Fort Sumter
Fort Sumter National Monument
Historic Structure Report

Volume II
APPENDICES A-F

The following review was performed by a team of historic building materials specialists including: Dorothy Krotzer, BCA Regional Director; George Wheeler, PhD, BCA Director of Scientific Research and Director of Conservation Research at Columbia University's Graduate School of Architecture, Planning, and Preservation; and John Walsh, President/Senior Petrographer and Magdalena Malaj Senior Chemist of Highbridge Materials Consulting, Inc. Ms. Krotzer provided comment on Part I – Developmental History and Part II – Treatment and Use, as well as the recommendations for conservation mortars proposed in Appendix K – Guidance for Conservation Mortars. Highbridge focused on the technical data and interpretations presented mostly in Appendix B – Materials Evaluation Report of the draft HSR, while Mr. Wheeler focused on issues related to salt distress.

On February 23rd, 2012, Highbridge was requested to perform a document review by Ms. Dorothy Krotzer of Building Conservation Associates, Inc. The document is a Historic Structure Report (HSR) for the Fort Sumter National Monument in Charleston, SC

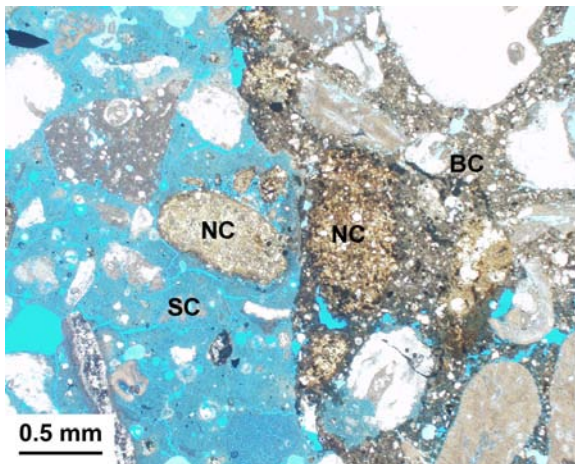
“The sand is an assembly of very small crystals, and this microstructure was common to all sanded mortars examined in this study”

What the author has misidentified as small crystals in Fig. 26 is the shattering of single quartz grains that occurs from aggressive thin section preparation. While this may seem minor it indicates a lack of understanding of several fundamental principles that would prevent the author from being able to interpret much else from his observations later in the report.
